Re: **ADDENDUM SEVEN - DELAWARE STATE POLICE - TROOP 3- BID PACK 1**
Dover, Delaware
2011116.00

ADDENDUM SEVEN

The addendum forms a part of the contract documents and modifies the original bidding documents dated, October 9, 2013, modified by Addendum No. 1 dated 10-18-2013, Addendum No. 2 dated 10-25-2013, Addendum No. 3 dated 10-31-2013, Addendum No. 4 dated 11-08-2013, Addendum No. 5 dated 11-11-2013, and addendum No. 6 dated 11-16-2013, as noted below.

SHEET
C-501

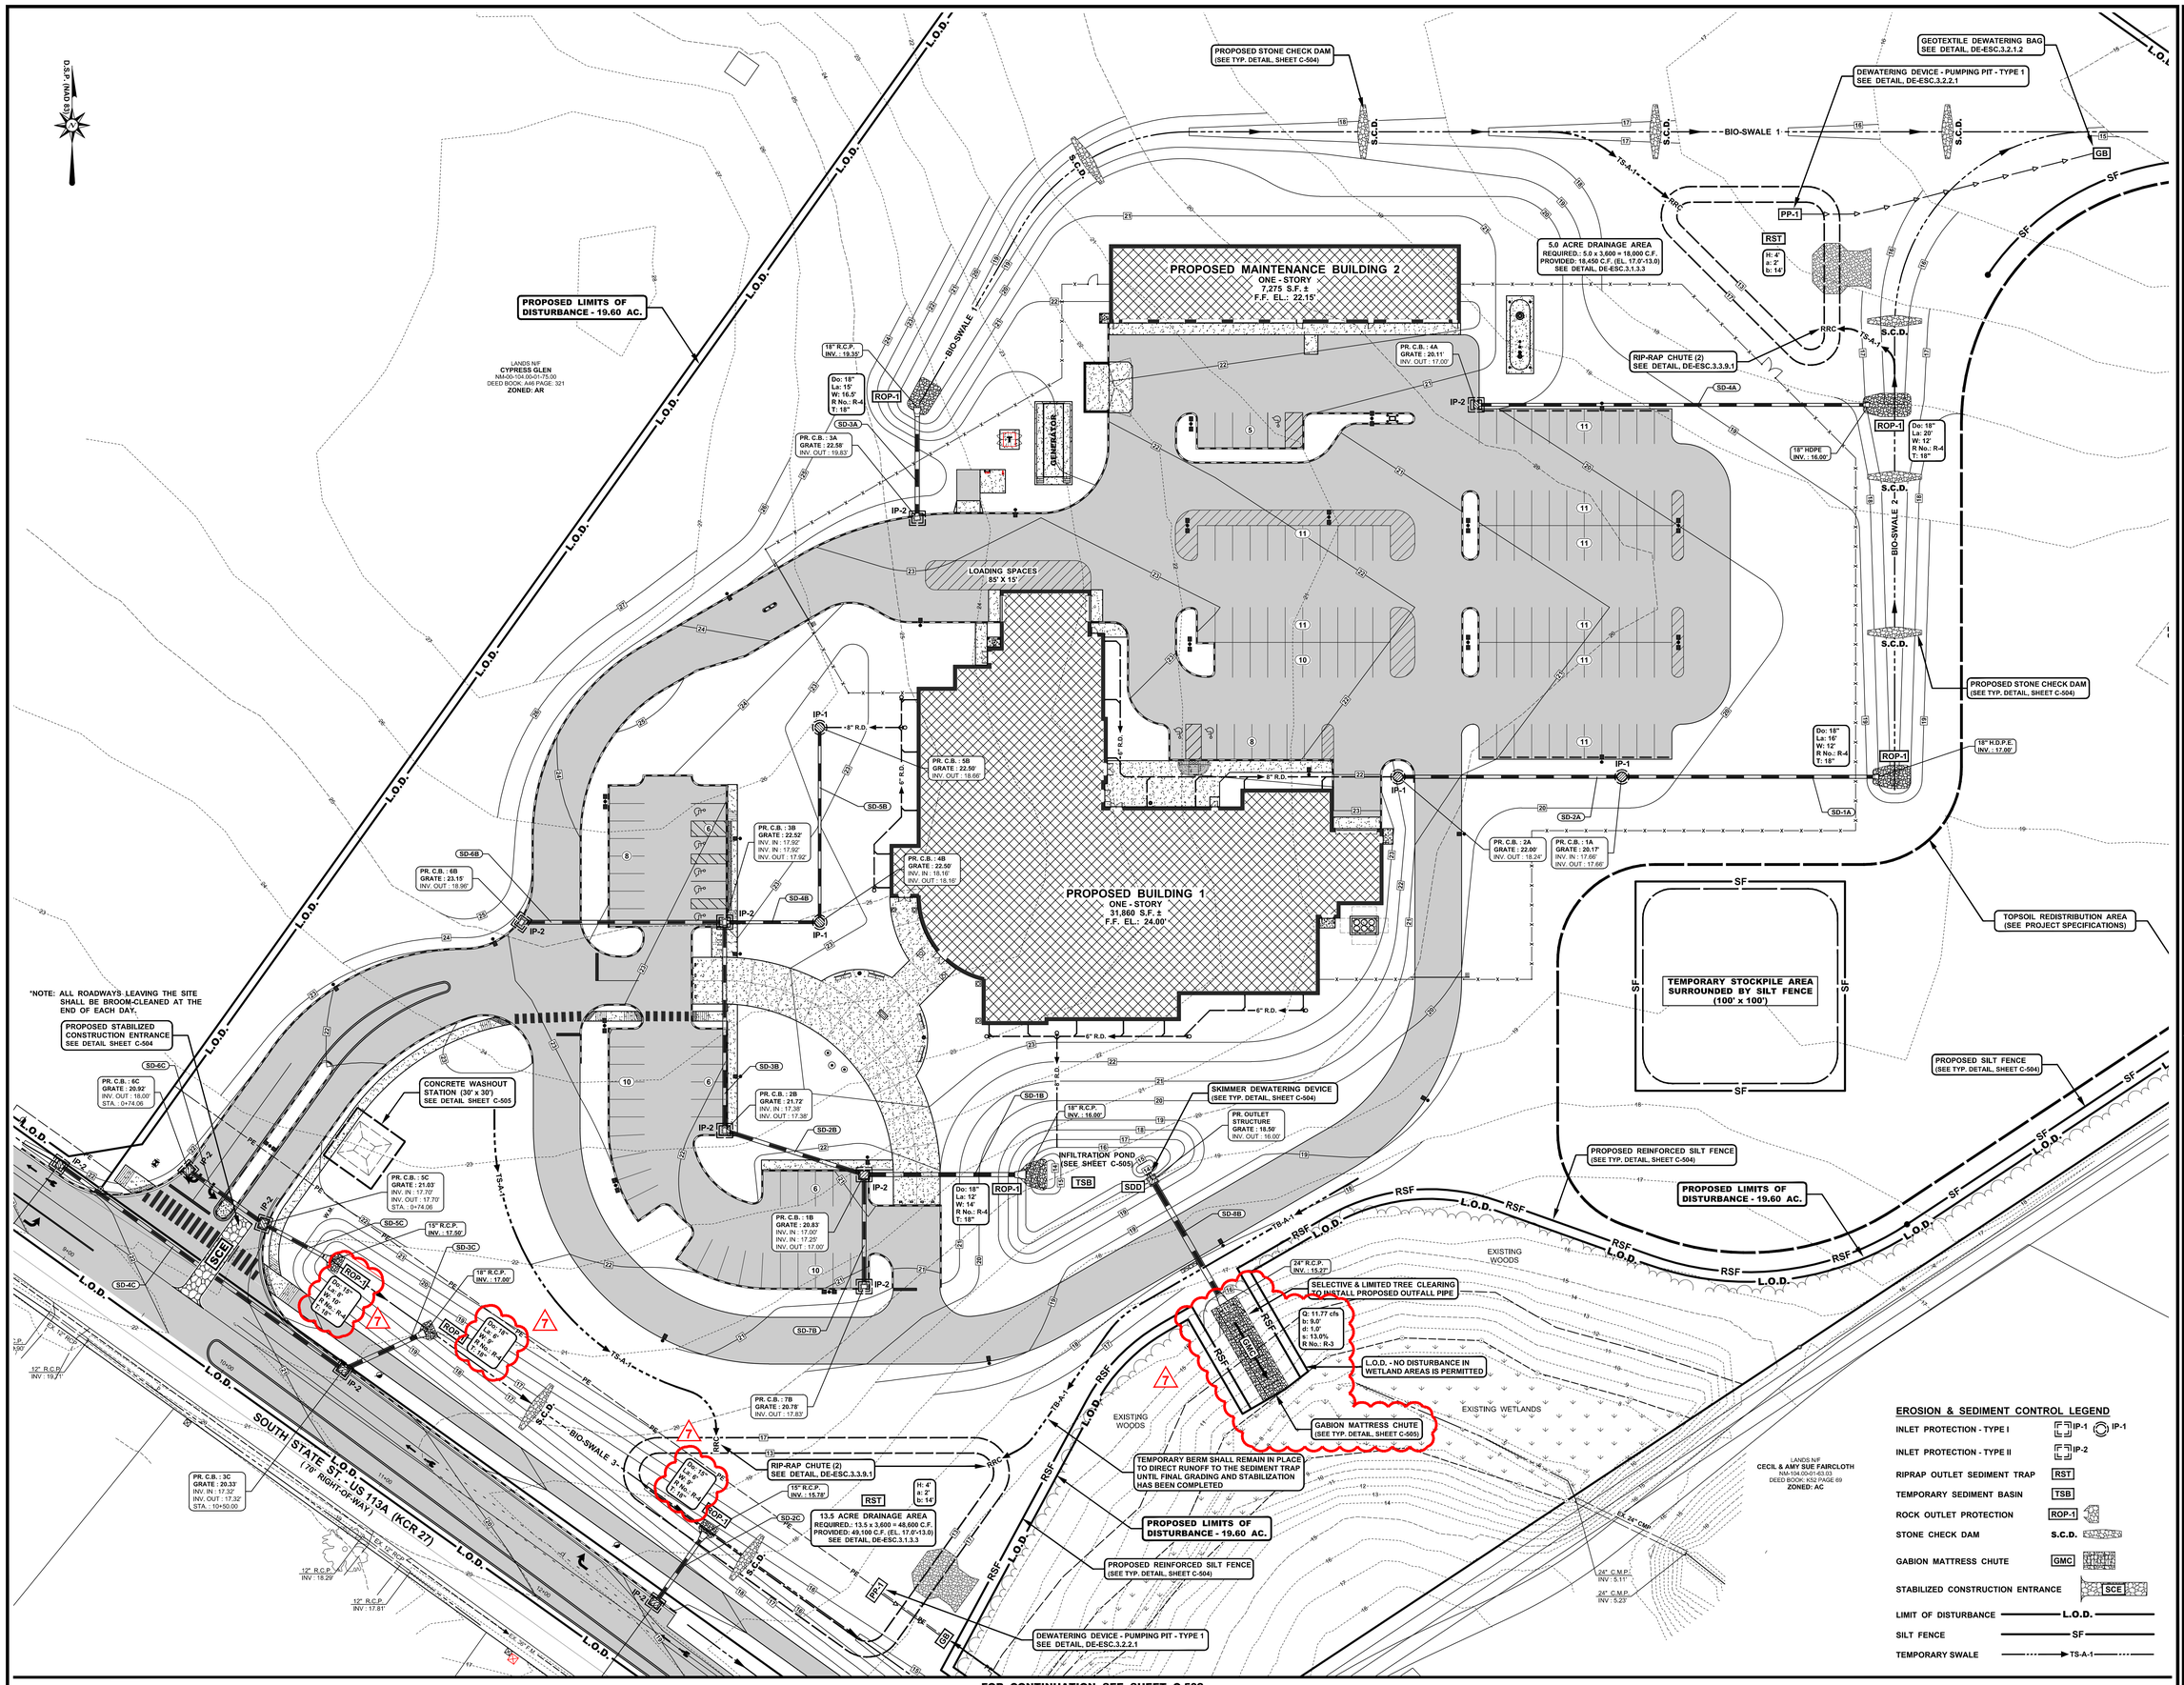
1. Sheet C-501 (Revised Sheet Reissued, see clouded revisions)
    a. Revised dimensions for rock outlet protection within bio-swale 3.
    b. Revised the outlet protection for SD-8B (infiltration pond discharge) to be a gabion mattress chute.

SHEET
C-503

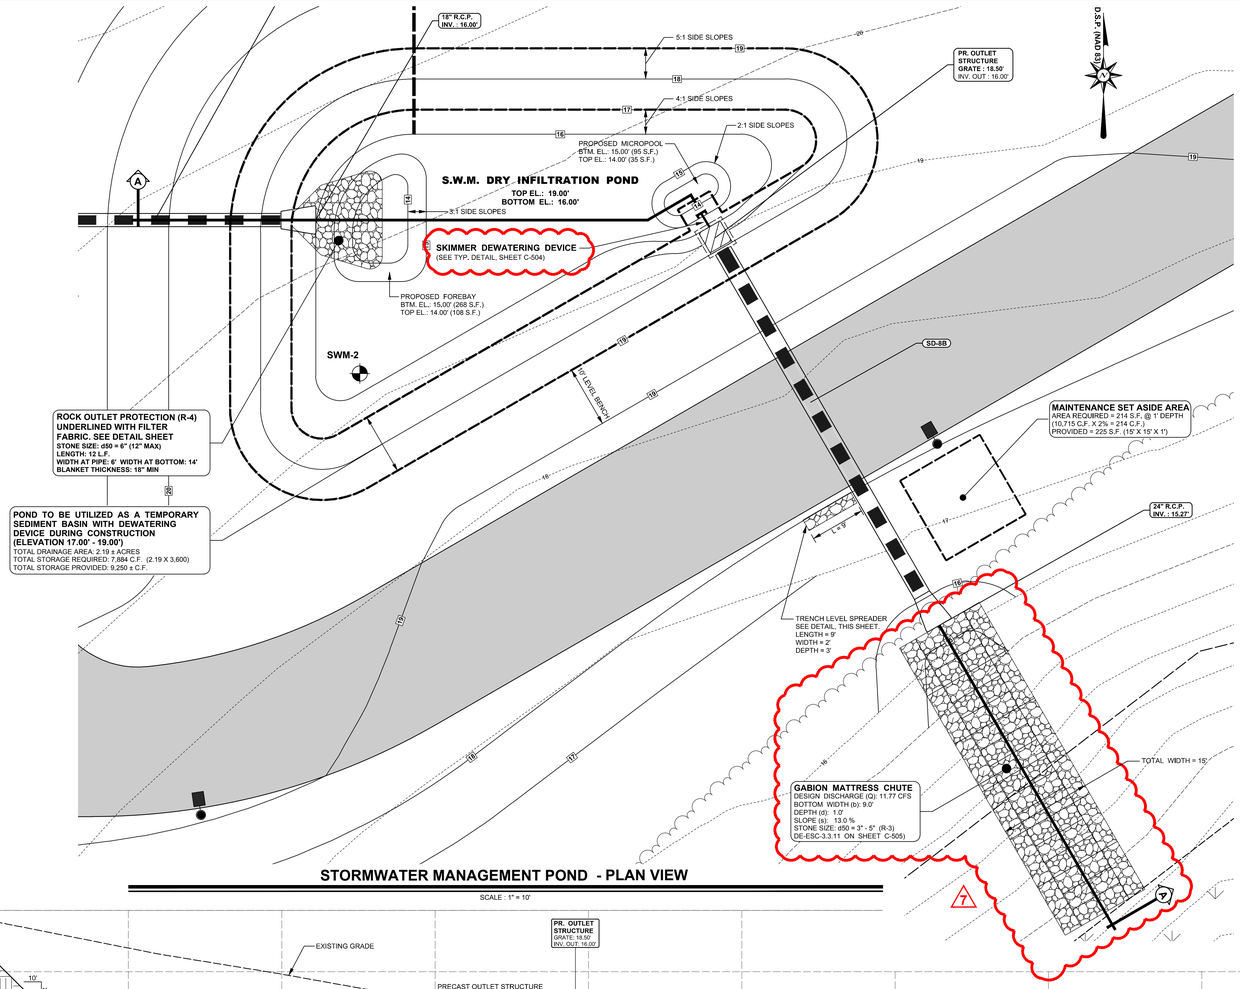
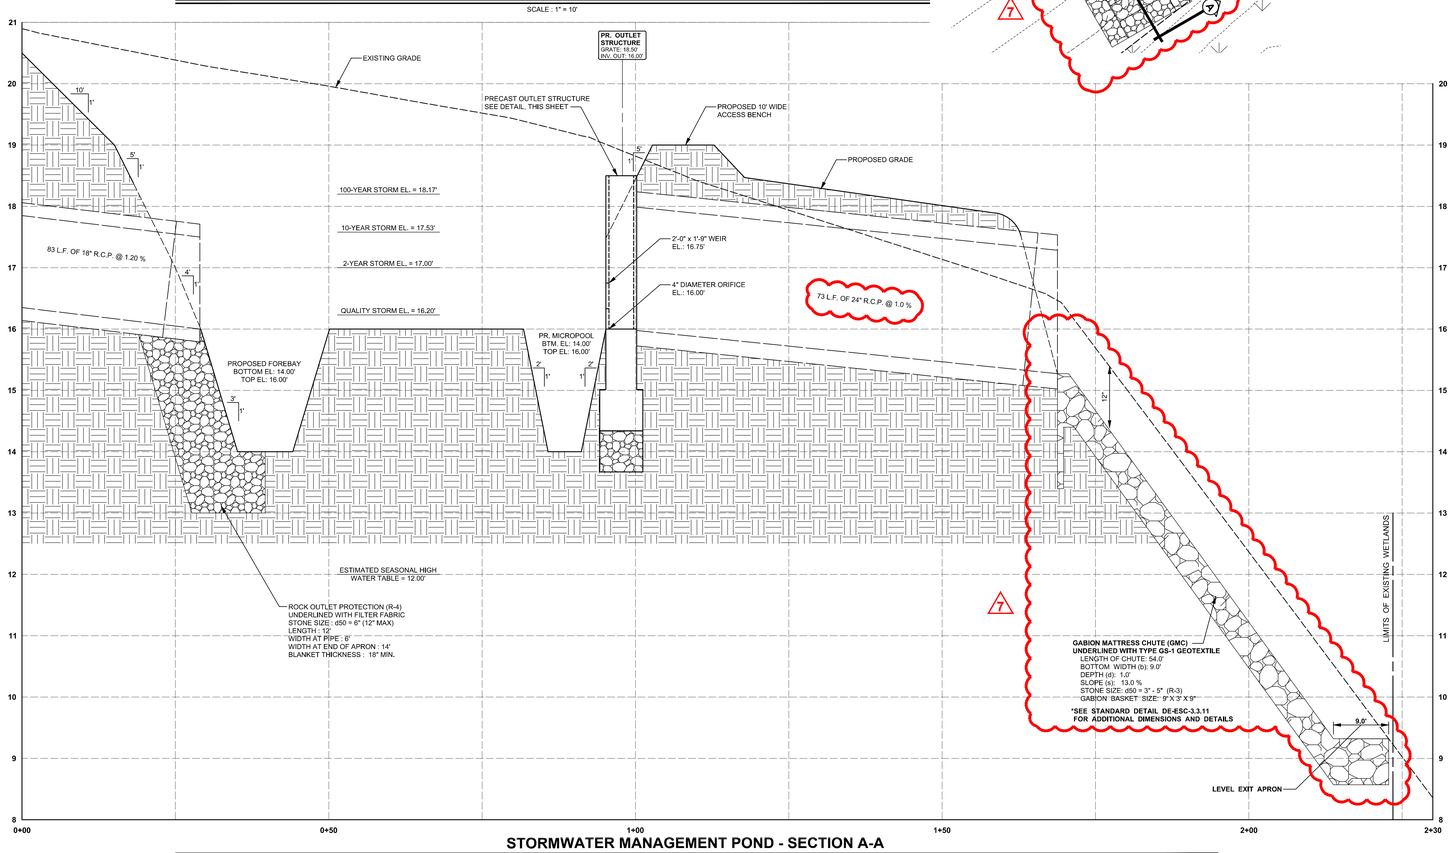
2. Sheet C-503 (Revised Sheet Reissued, see clouded revisions)
    a. Reduced the length of SD-8B.
    b. Revised the outlet protection for SD-8B (infiltration pond discharge) to be a gabion mattress chute.

c. Added skimmer dewatering device and associated note.
3. Sheet C-505 (Revised Sheet Reissued, see clouded revisions)
    a. Added gabion mattress chute standard details.

1 SITE PLAN – ELECTRICAL LIGHTING
E-20 SCALE: 1/32"=1'-0"

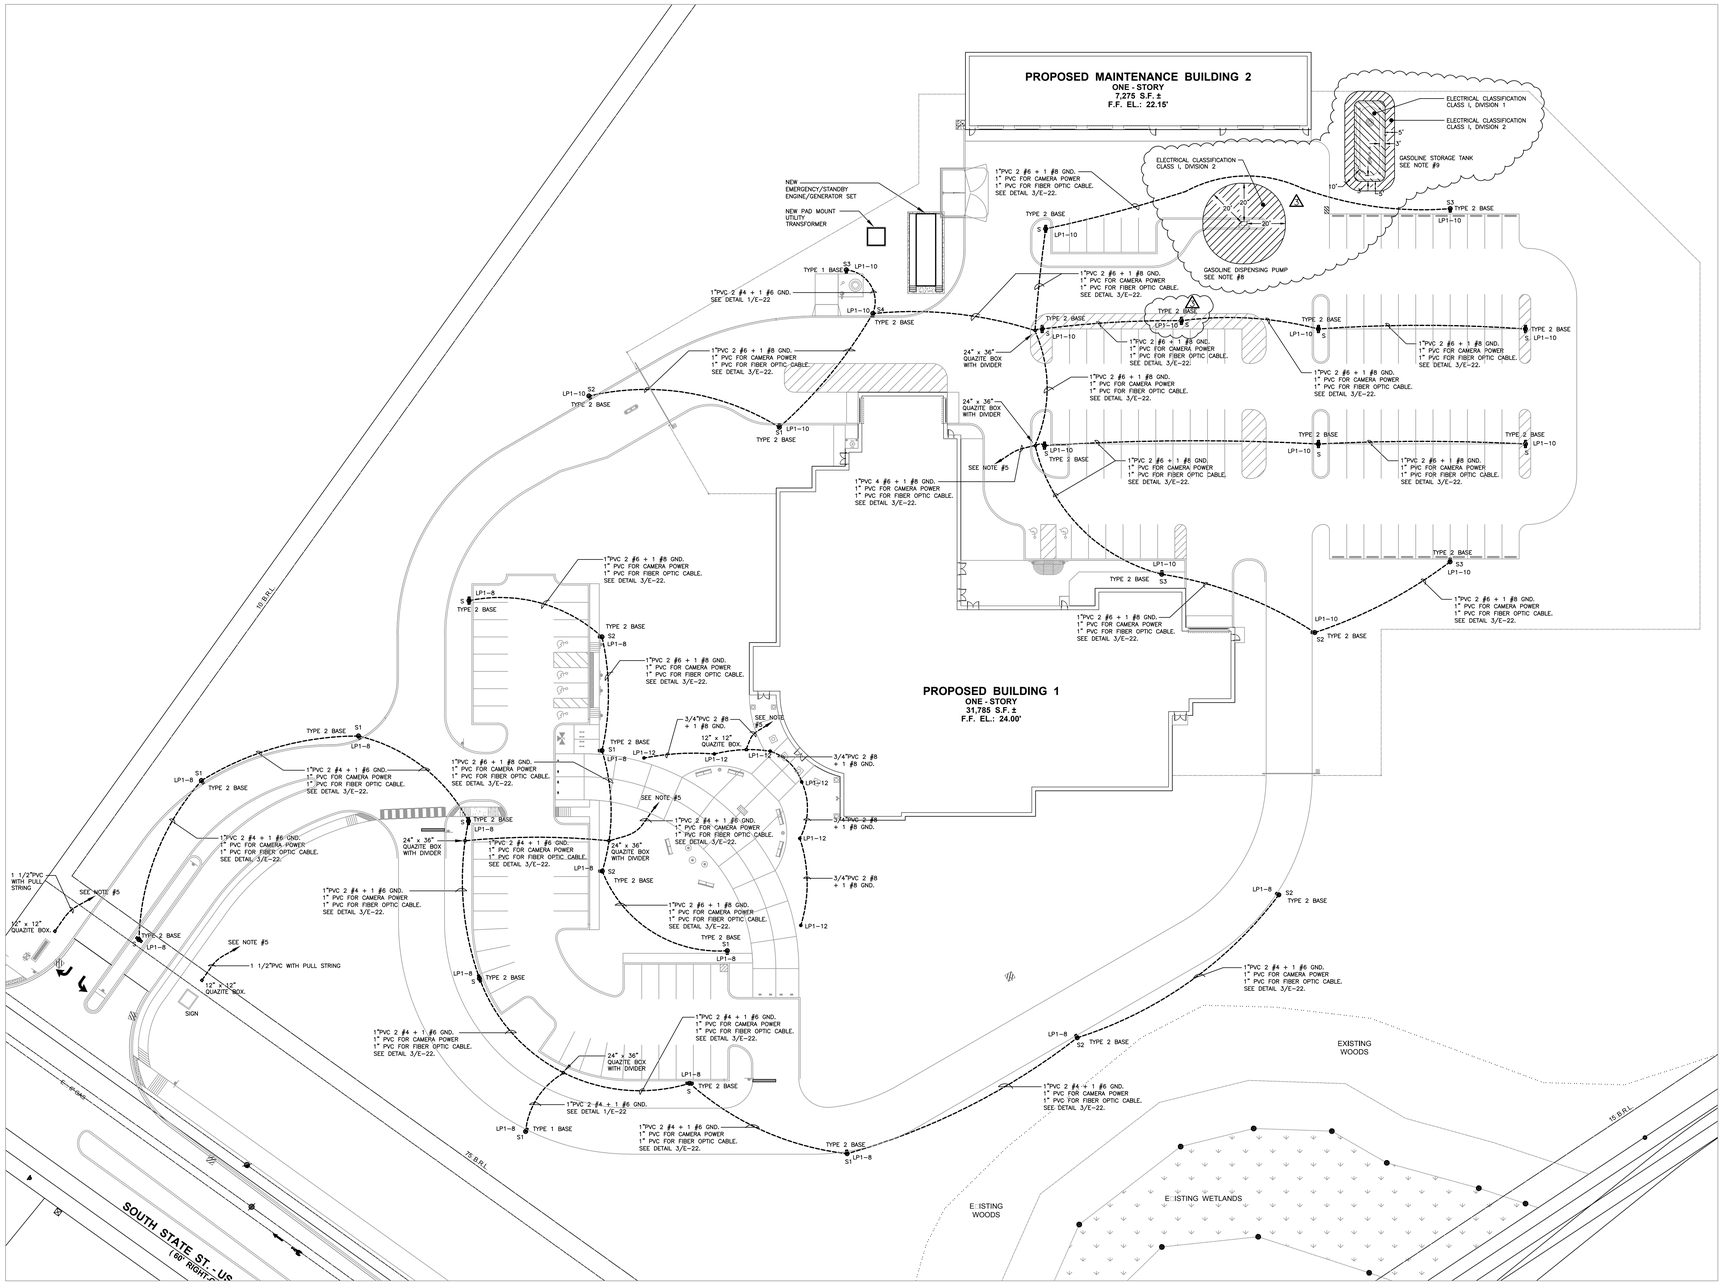
4. Sheet E-20 (Revised Sheet Reissued, see clouded revisions)
    a. Deleted type “S” light fixture and associated concrete anchor base next to the gasoline dispensing pump.

b. Change light fixture across from the gasoline dispensing pump from type “S3” to type “S”. The concrete anchor base remains the same.
    c. Identified the electrical classification areas around the gasoline dispensing pump, and the above ground gasoline storage tank.

d. Added general notes #8 and #9.
5. Sheet E-21 (Revised Sheet Reissued, see clouded revisions)
    a. Identified the electrical classification areas around the gasoline dispensing pump, and the above ground gasoline storage tank.

8. UNDERGROUND CONDUITS ARE NOT PERMITTED WITHIN THE ELECTRICALLY CLASSIFIED AREA. ONLY CONDUITS THAT ARE ASSOCIATED WITH THE GASOLINE DISPENSING PUMP ARE PERMITTED WITHIN THE AREA. (3)

9. UNDERGROUND CONDUITS ARE NOT PERMITTED WITHIN THE ELECTRICALLY CLASSIFIED AREA. ONLY CONDUITS THAT ARE ASSOCIATED WITH THE ABOVE GROUND GASOLINE STORAGE TANK ARE PERMITTED WITHIN THE AREA.
